ARCHITECTURAL REVIEW FINDINGS AND DECISION

**** APPROVAL WITH CONDITIONS ****

Case #:	AR-15-0018
Project:	Emergency Veterinary Clinic Remodel
Location:	8250 SW Tonka St (Tax Lots 2S1 24CB 01700 & 1805)
Applicant:	Rebecca Kerr, CIDA, Inc. (503-226-1285; Job No. 140221.02); JoAnne Wisniewski

PLANTING PLAN
SCALE 1" = 20'

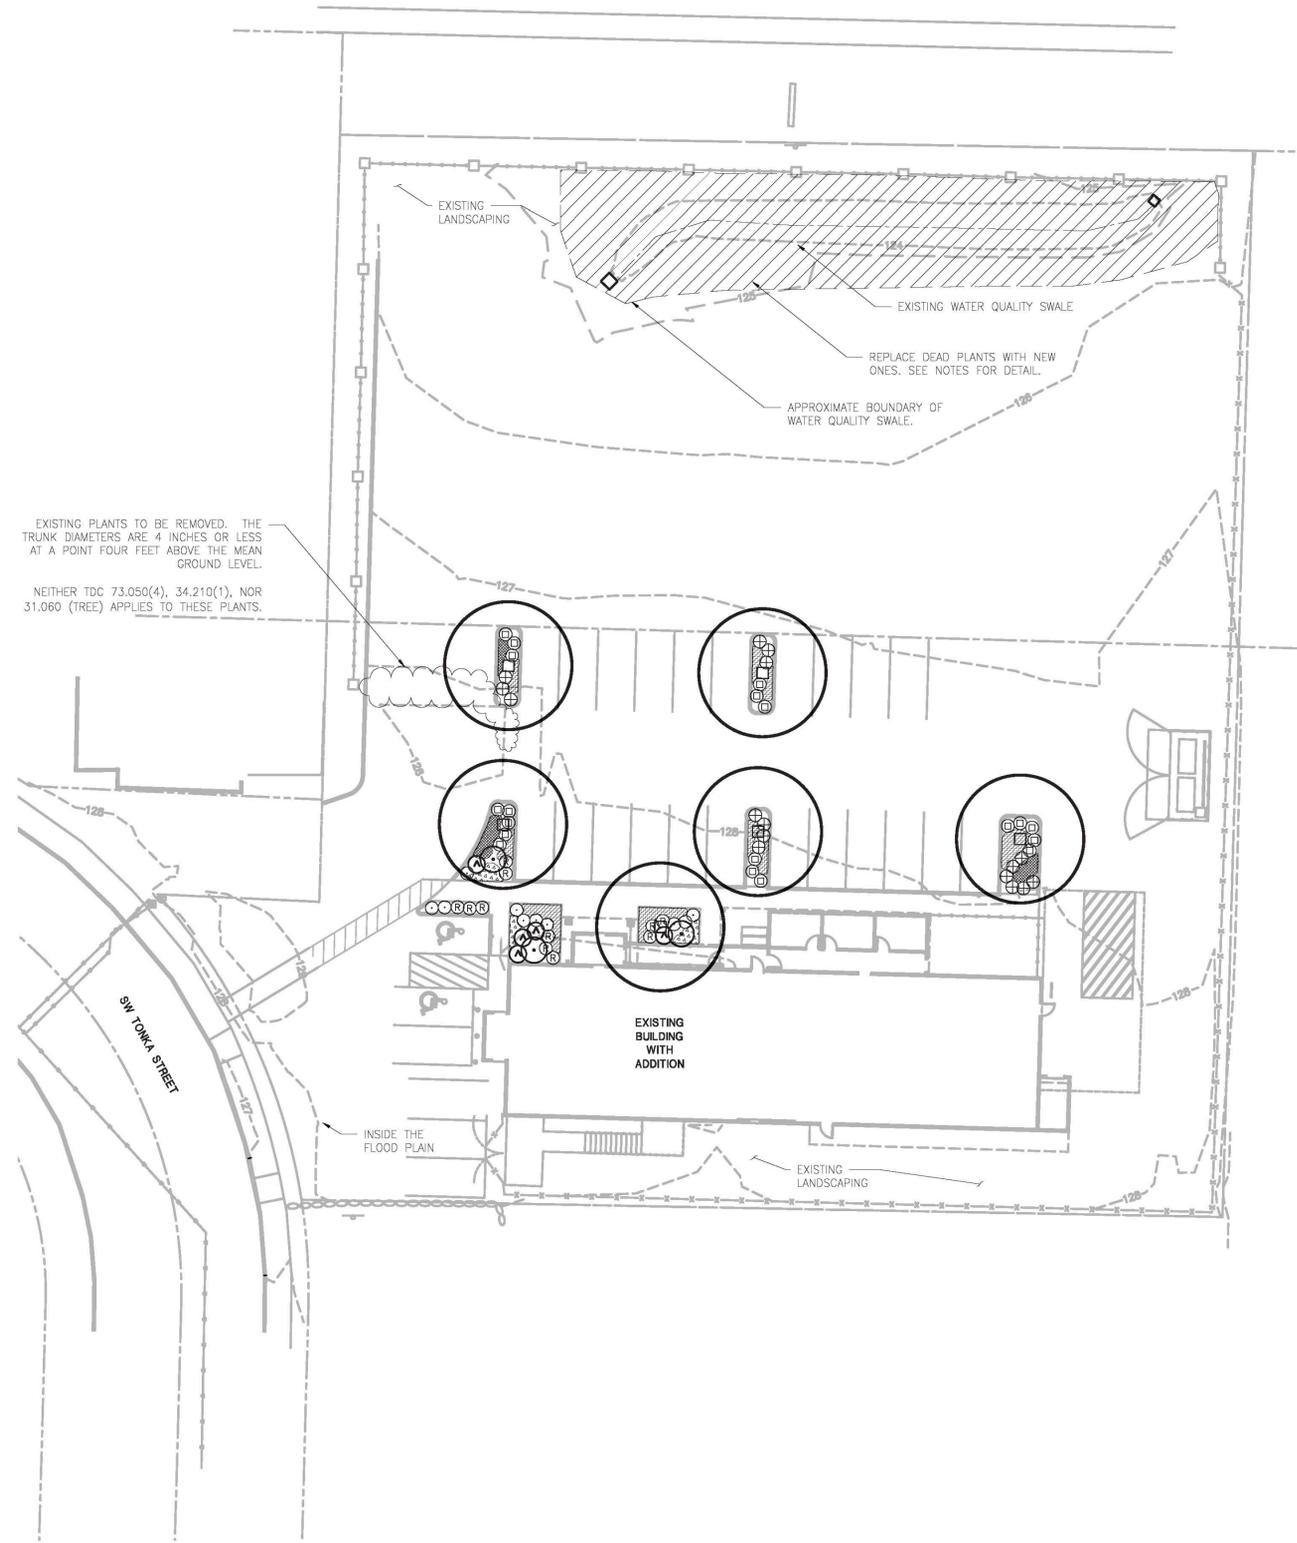
- The applicant shall revise the planting plan to illustrate evergreen shrubs along the trash and recycling enclosure walls.

- The applicant shall revise the planting plan to illustrate in the landscaped island between the driveways where a deciduous shade tree will be planted meeting the requirement of 73.260(1)(a) in the southern part of the island and south of the proposed walkway.

- The applicant shall revise the planting plan to illustrate landscaping along the north side of the east addition.

1 SITE PLAN
1/16" = 1'-0"
NORTH

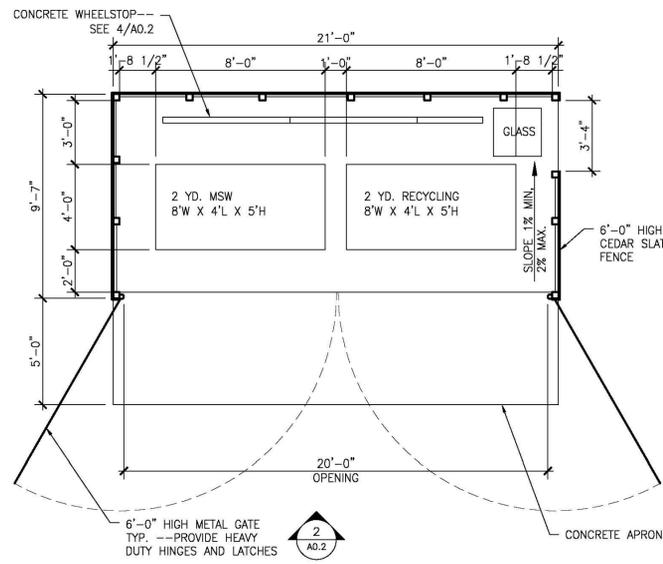
- The applicant shall revise the site plans to provide an accessway between the SW Tonka Street sidewalk and the building perimeter walkway. The proposed no-parking circulation area between the handicapped parking stalls may also serve as an accessway segment.

- The applicant shall revise the site plans to illustrate a curb ramp wherever a walkway or accessway mounts a curb.

- The applicant shall revise the site plans to illustrate and note that the required accessway is paved at least 8 feet wide and its drive aisle crossing is of a different appearance than the adjacent paved vehicular areas, such as through striping.

- The applicant shall revise the site plans to illustrate the east end of the north side of the east-west drive aisle capped with a landscaped island meeting the requirement of 73.360(2).

- The applicant shall revise the site plans to illustrate and note bicycle parking signage, proposing at least one sign at the main entrance directing cyclists in the direction of the bicycle parking and one at each rack.

- The applicant shall either revise the site plans to illustrate 31 total off-street parking spaces or as allowed by 73.370(1)(a) submit evidence that a lesser number of vehicle parking spaces will be sufficient.

1 TRASH ENCLOSURE PLAN
A0.2 NOT TO SCALE

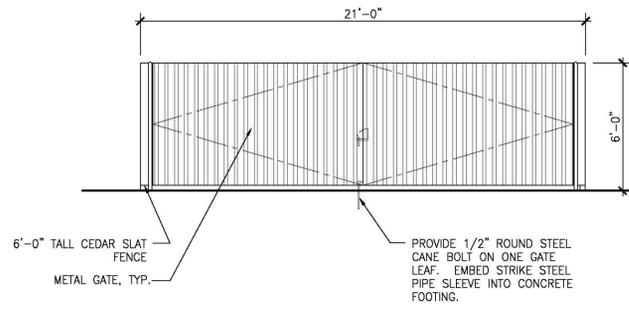
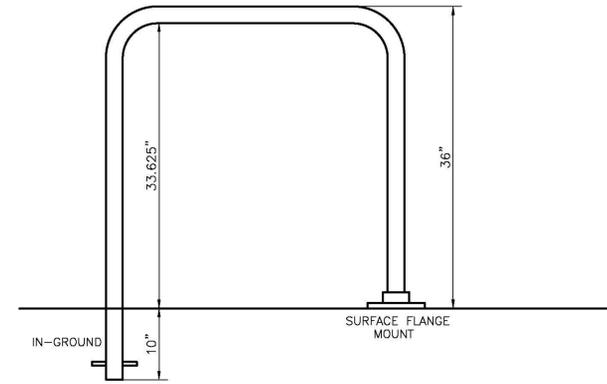
The site details sheet illustrates the trash and recycling enclosure with a 6-foot wall, a gate opening of 20 ft and sight-obscuring gates capable of being secured in a closed and open position, and a separate pedestrian access. However, because the site redevelopment area is commercial and the enclosure lacks evergreen plants placed around its walls, the requirement is not met, and staff is applying a condition.

2 WEST ELEVATION
A2.1 1/8" = 1'-0"

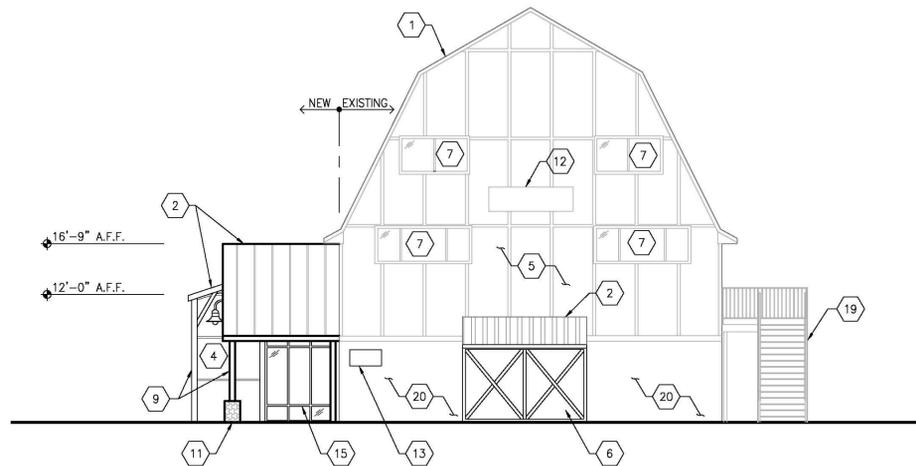
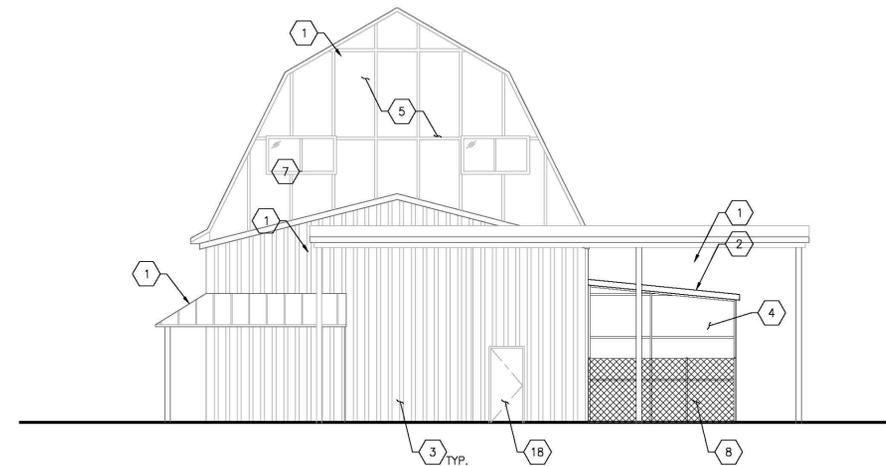
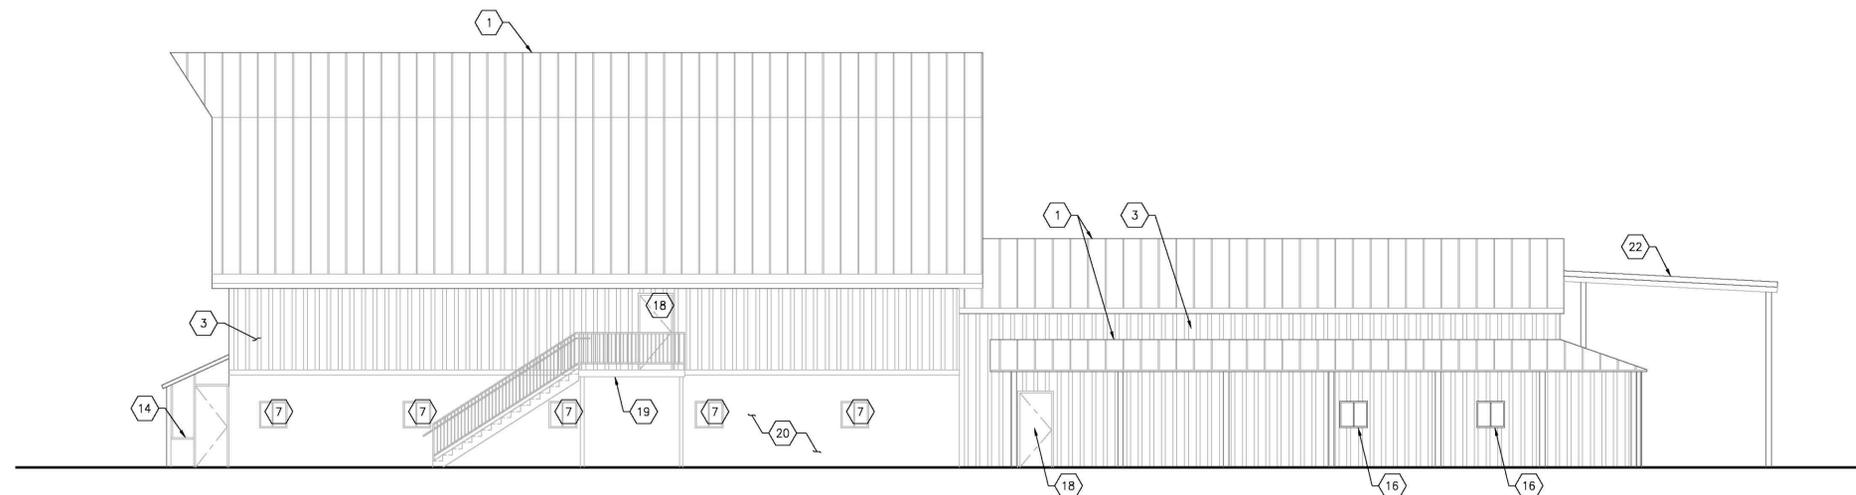
Because the elevations do not illustrate or note existing or modified address numerals, the requirement of (d) is not met, and staff is applying a condition.

- The applicant shall revise the elevations to illustrate or note address numerals that meet the needs of Tualatin Valley Fire & Rescue (TVF&R).

SITE LIGHTING PLAN
SL1.1
JOB NO. 140221.02
© 2015 CIDA, P.C./CIDA ALL RIGHTS RESERVED

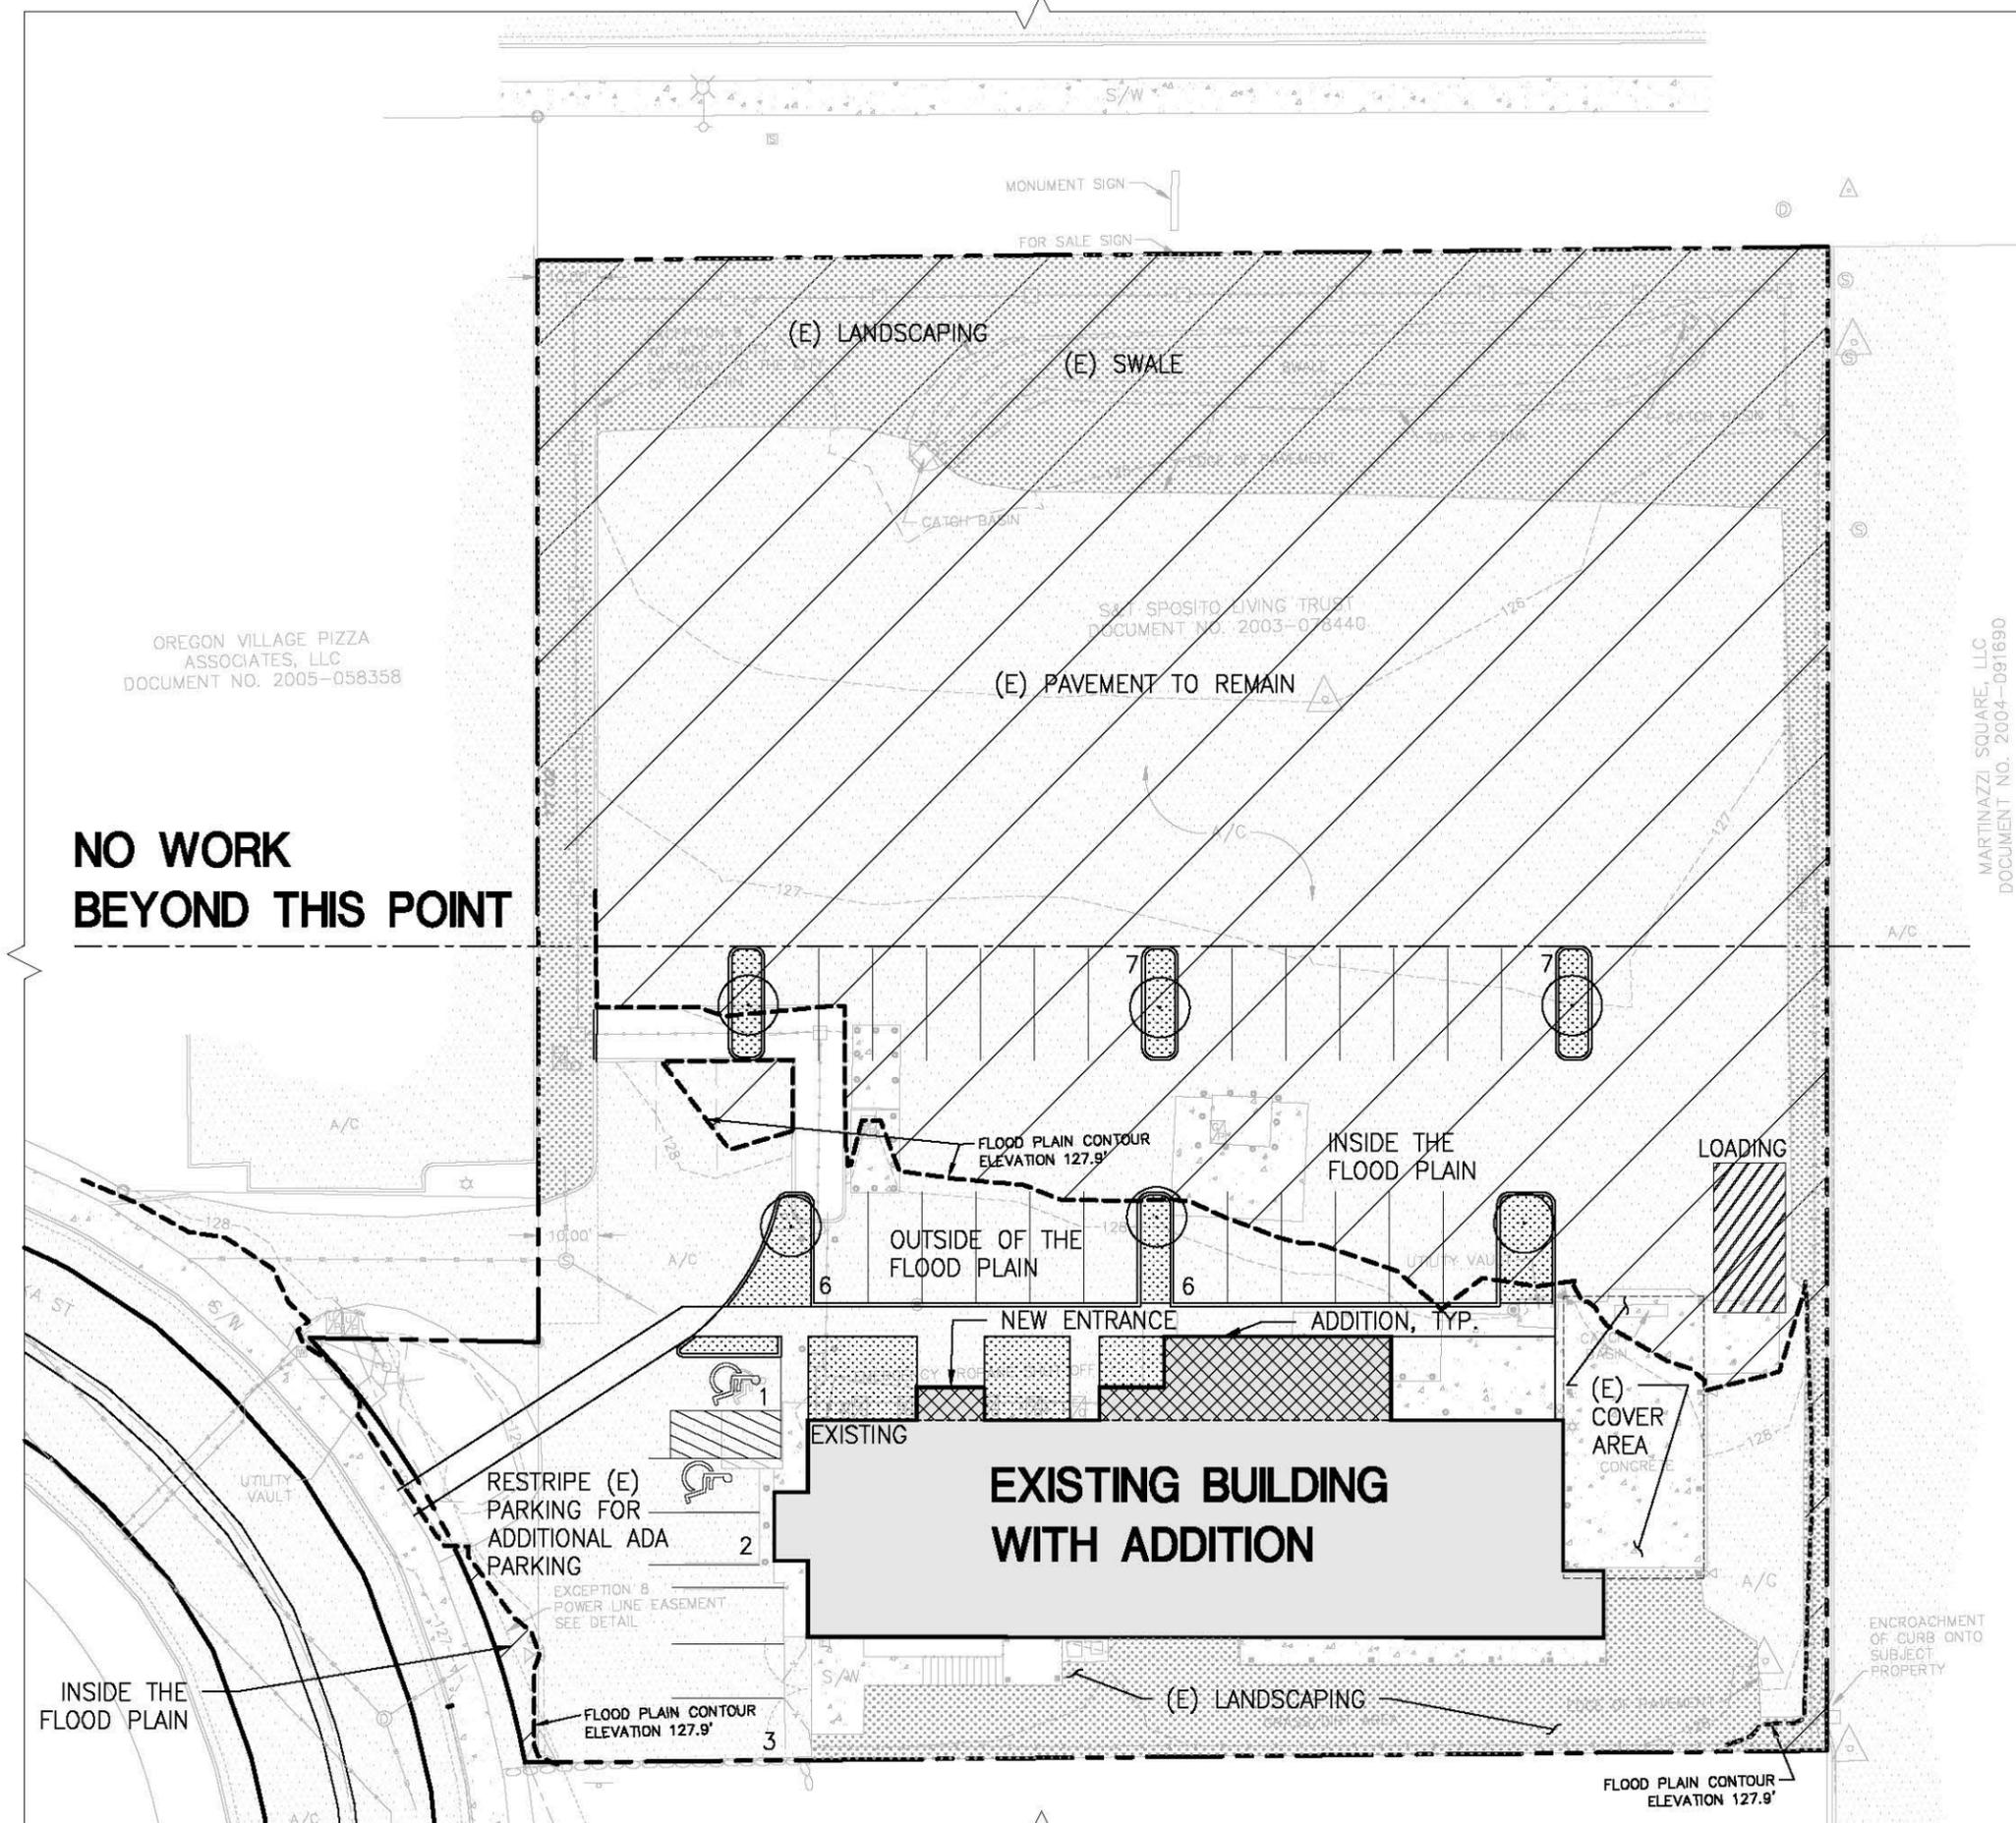
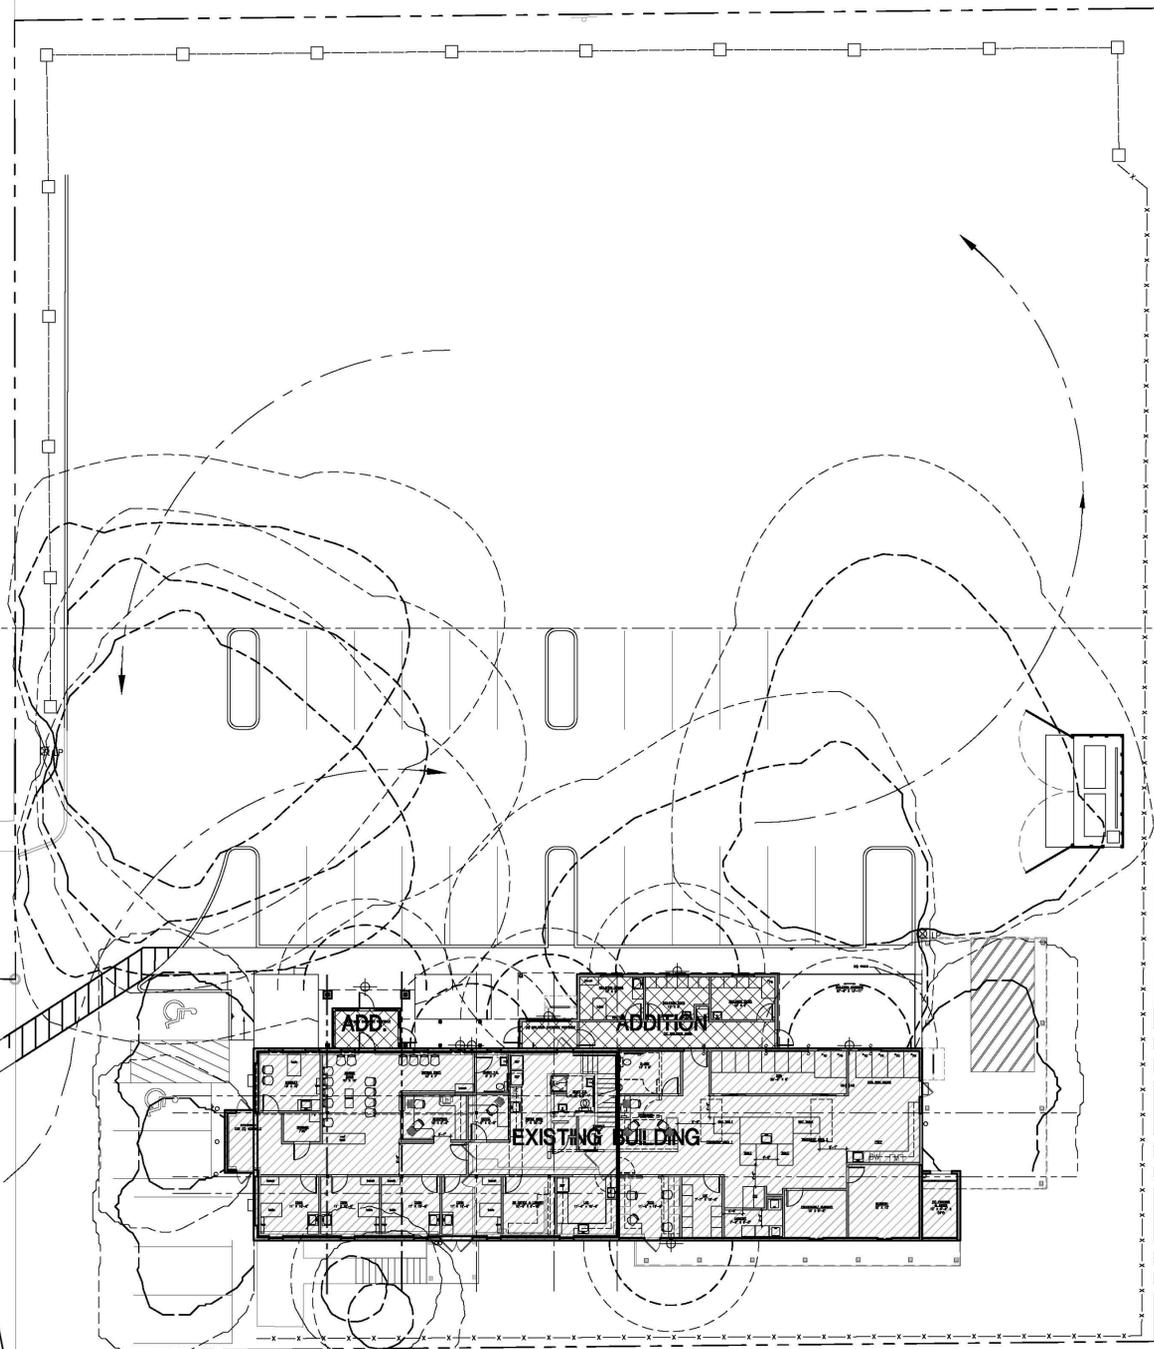
- The applicant shall revise the lighting plan to reference a full cut-off model, to make any additional north wall fixtures be full cut-off, and to submit a technical cut sheet or sheets for such a full cut-off model. The *Guidelines for Good Exterior Lighting Plans* (Attachment 104) is available as an implementation aid.
